RE: St. Lucie Units 1 and 2 and Turkey Point Units 3 and 4
Docket Nos. 50-335, 50-389, 50-250, and 50-251
Response to NRC Bulletin 2001-01

Turkey Point Units 3 and 4
Response to NRC Bulletin 2001-01

St. Lucie Units 1 and 2
Response to NRC Bulletin 2001-01

Figure 1: Turkey Point Units 3 & 4 Nominal Elevation Schematic of Components Above the Head

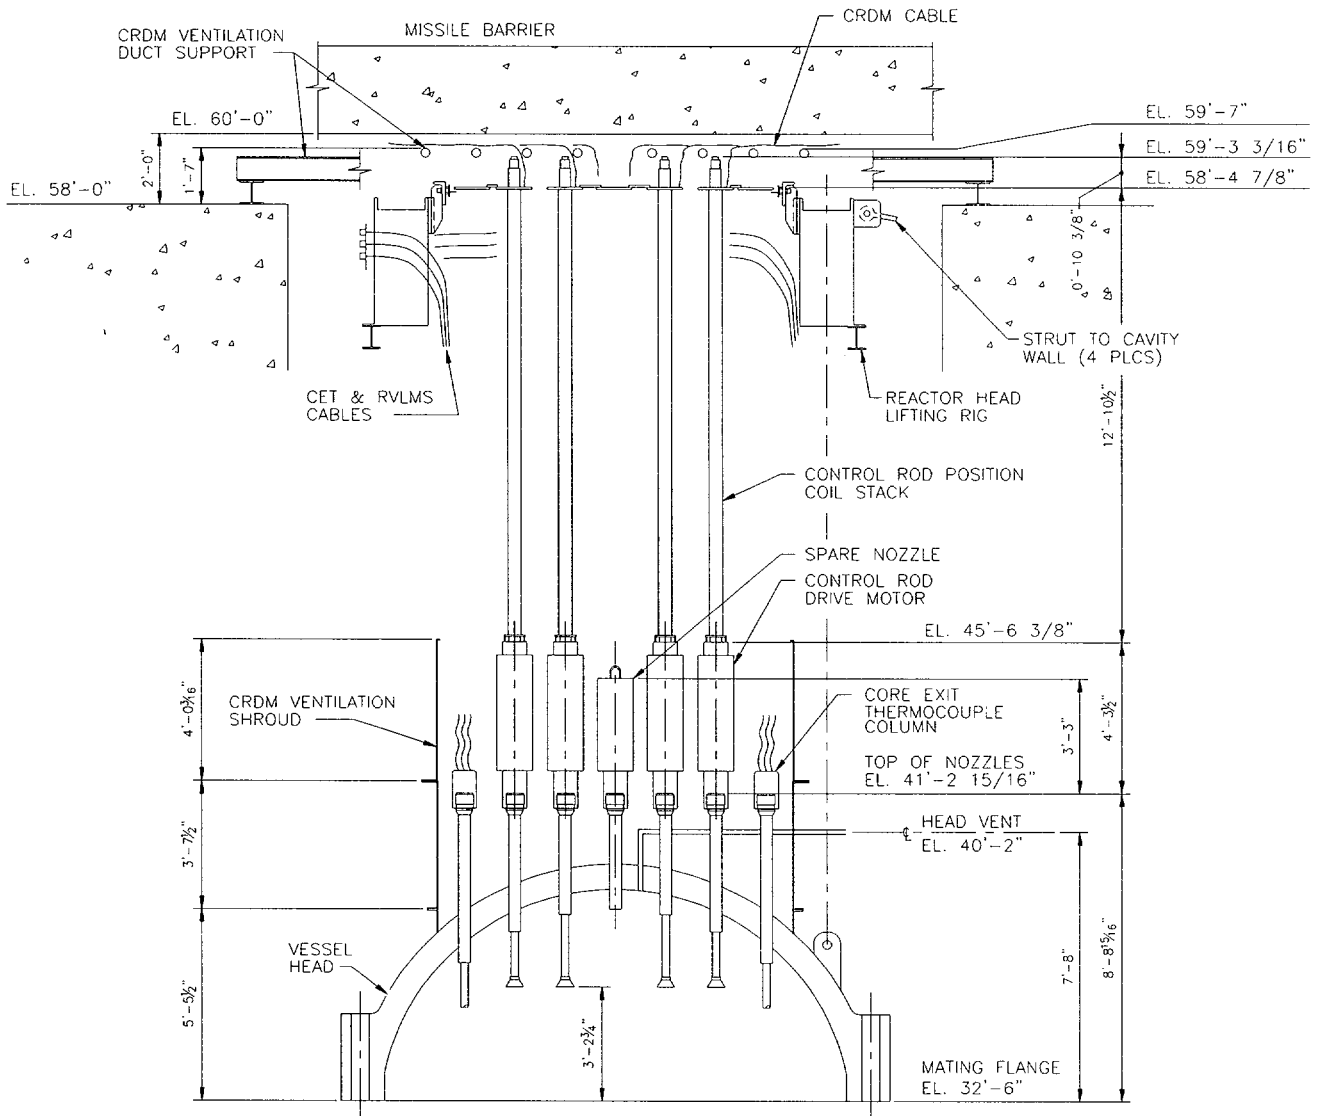
NRC Question 1e: a description of the configuration of the missile shield, the CRDM housings and their support/restraint system, and all components, structures, and cabling from the top of the RPV head up to the missile shield. Include the elevations of these items relative to the bottom of the missile shield.

FPL Response to NRC Question 1e: There are 66 reactor vessel head penetrations for each of the reactor vessels at Turkey Point Units 3 and 4. Of these, 45 are active CRDMs, 2 are used for the reactor vessel level monitoring system (RVLMS), 4 are for the core exit thermocouple (CET) columns, 6 are part length CRDMs with the lead screws retracted and pinned in the housing, 8 are spare CRDM nozzle penetrations with no current use, and there is one head vent penetration. Figure 1 shows a representation of the elevation view depicting the various components above the reactor head.

As shown in Figure 1, each of the CRDMs including the part length CRDMs are supported laterally at the 58'-4 7/8" elevation. The support is provided by capturing the square plates at the top of the control rod position coil stack forming a checker board configuration within the perimeter of the reactor head lifting rig box beam. Using a series of jacking screws along with dummy plates at those locations not containing a CRDM, these plates are captured with a clearance of approximately 1/4" between sides of adjacent plates. This checker board/ lifting rig assembly is then secured to the reactor cavity wall with four equal spaced rigid struts. The spare penetrations are fitted with a short, ventilation flow restrictor box that has no additional lateral restraint. For the CET and RVLMS penetrations, the assemblies terminate just above the nozzles with cable connections.

The cables for the CETs and the RVLMS are gathered, tie-wrapped and secured to the vertical legs of the reactor head lifting rig. The cables continue to the upper area of the reactor head lifting rig, around the inside of the lifting rig box beam and terminate at two adjacent connector panels on the side of the lifting rig box beam. These cables then exit the reactor cavity across two cable trays.

For the CRDMs, the cables rise a short distance as shown in Figure 1, are draped over and then tie-wrapped to a series of support elements that are part of the CRDM ventilation duct support. The cables are routed across these support elements to four quadrant points where the cables enter cable trays to exit to the plant.

The reactor vessel missile barrier consists of two rectangular reinforced concrete slabs each 29' x 11' x 2'6" and weighing approximately 120,000 lbs. The two barrier slabs are centered over the reactor head and overlap along their inner edge. A cut out, approximately 8'6" x 6', is formed on each end of the joined slabs to allow passage of the CRDM ventilation ducts. This results in the center 12'6" of the inner 29' edge overlapping. The Updated Final Safety Analysis Report (UFSAR) states that this removable reinforced concrete frame is provided to block any missile that could be generated by a CRDM ejection event.

Figure 1: Plan and Cross Sectional View of the St. Lucie Unit 1 RPV Head Insulation

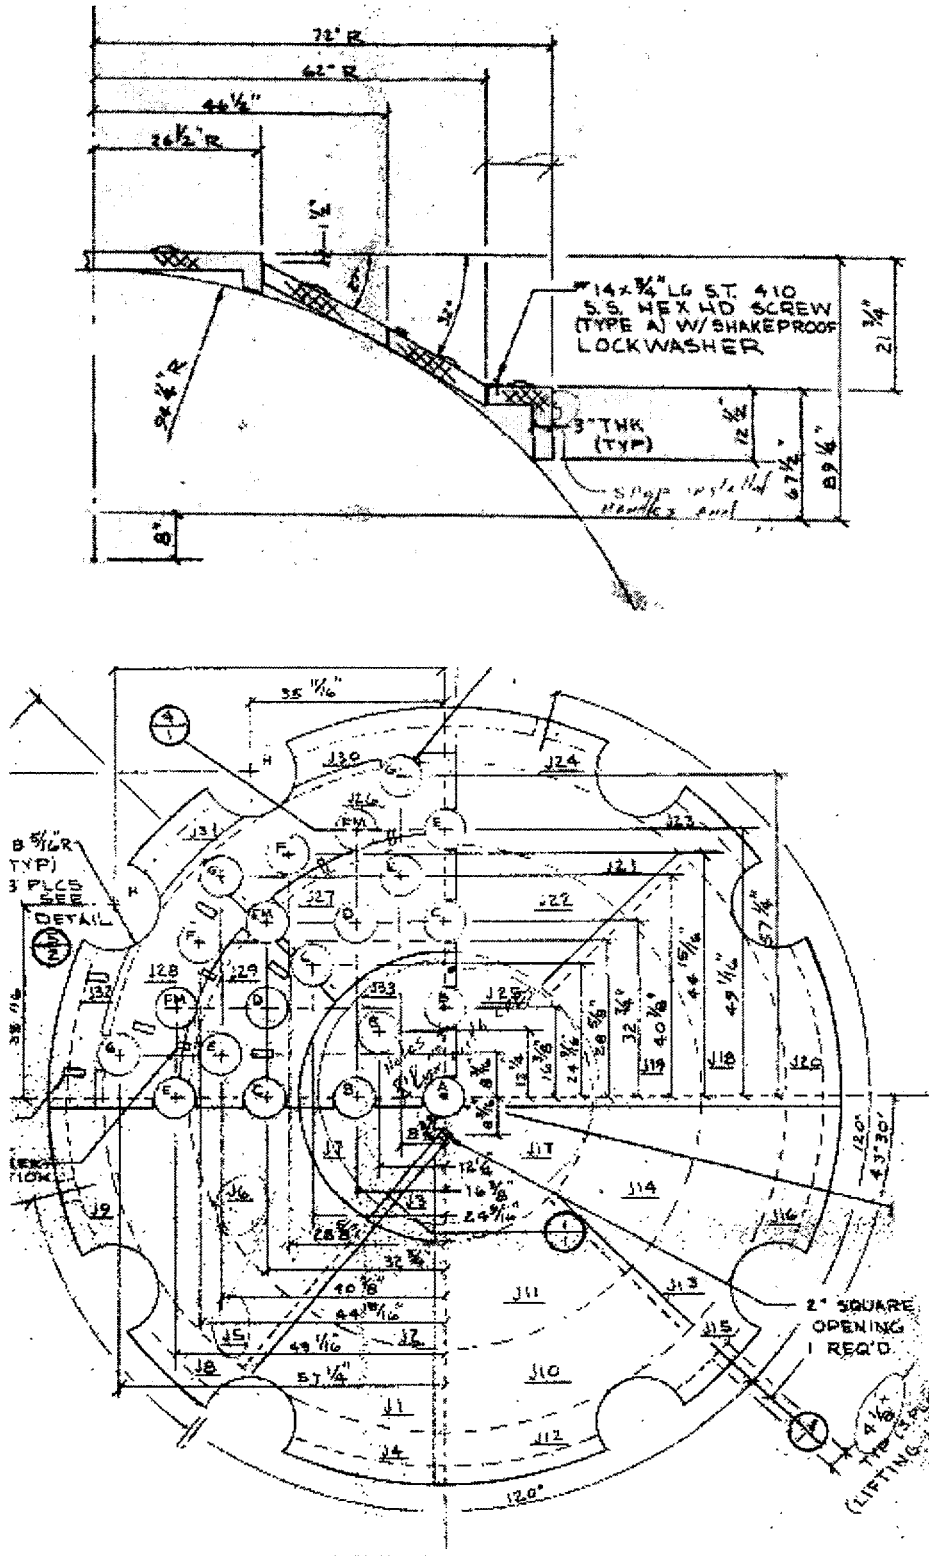
NRC Question 1c: a description of the RPV head insulation type and configuration;

FPL Response to NRC Question 1c: The insulation type at St. Lucie Unit 1 is metal reflective encapsulated mineral wool. The insulation conforms to the head as do the lower CRDM pressure housings. The insulation is made up of 33 panels, 21 of which encircle the 69 CRDM nozzles. The encircling panels were installed over the lower CRDM pressure housing flanges during initial construction. The gap between the insulation panels and the VHPs are filled with plug rings (containing asbestos insulation), that were installed prior to the panels and secured with a metal band. Figure 1 shows the general arrangement of the insulation.

Figure 5: St. Lucie Unit 2 Nominal Elevation Schematic of RPVH Components and The Missile Shield Above the Head (not to scale)

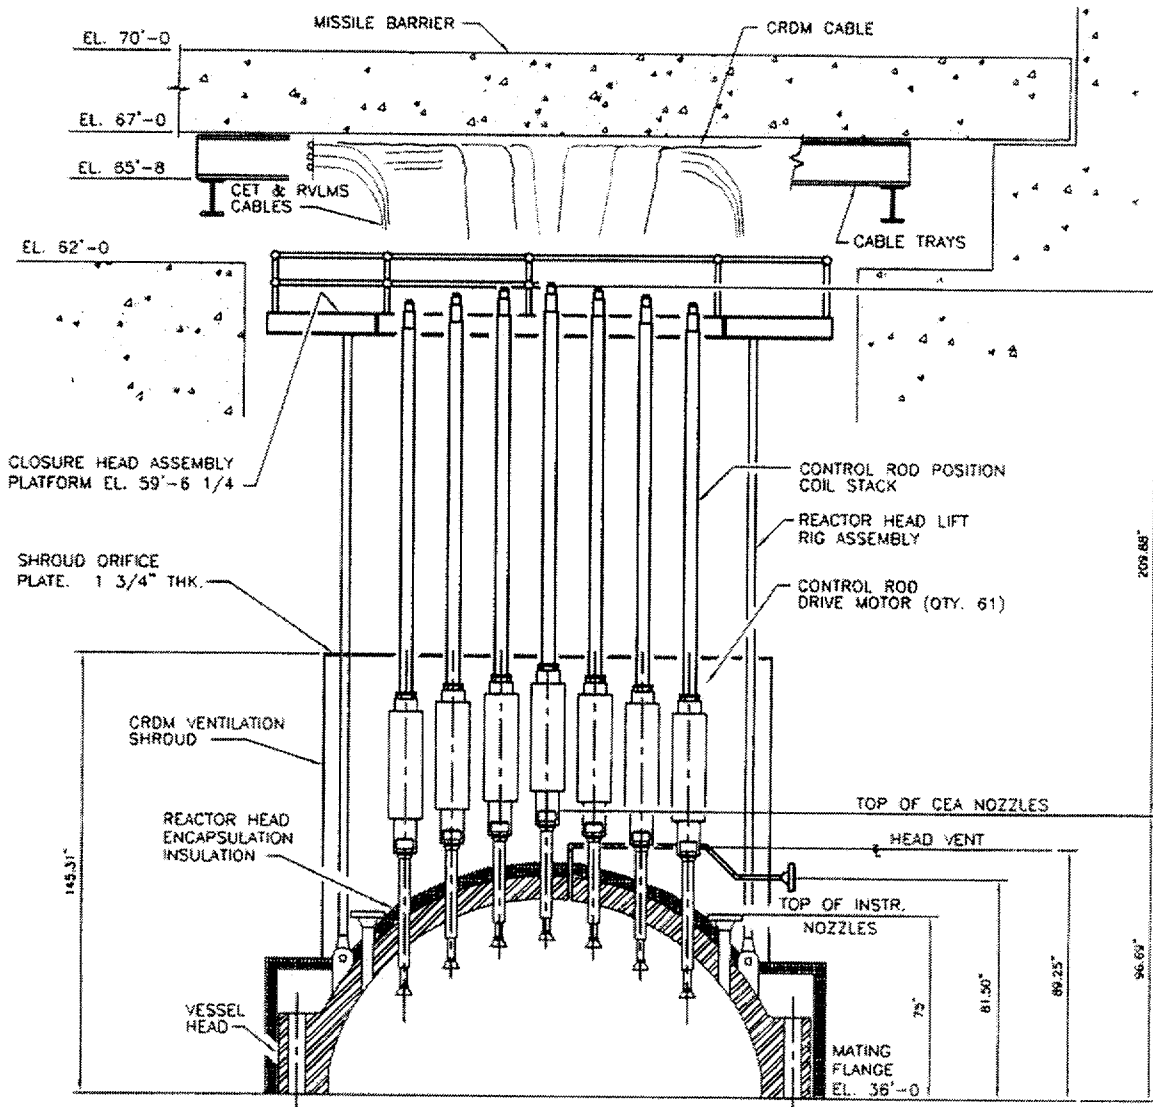
NRC Question 1e: a description of the configuration of the missile shield, the CRDM housings and their support/restraint system, and all components, structures, and cabling from the top of the RPV head up to the missile shield. Include the elevations of these items relative to the bottom of the missile shield.

St. Lucie Unit 2 - The bottom of the missile shield is at elevation 68.0 feet. The flange face of the RPVH is at elevation 36.0 feet. The separation from the reactor head flange face to the bottom of the missile shield is 32.0 feet. There are 91 CRDM nozzle penetrations, 10 instrument nozzles, and one head vent penetration. The relative height of each is shown in the attached Unit 2, Figure 5.
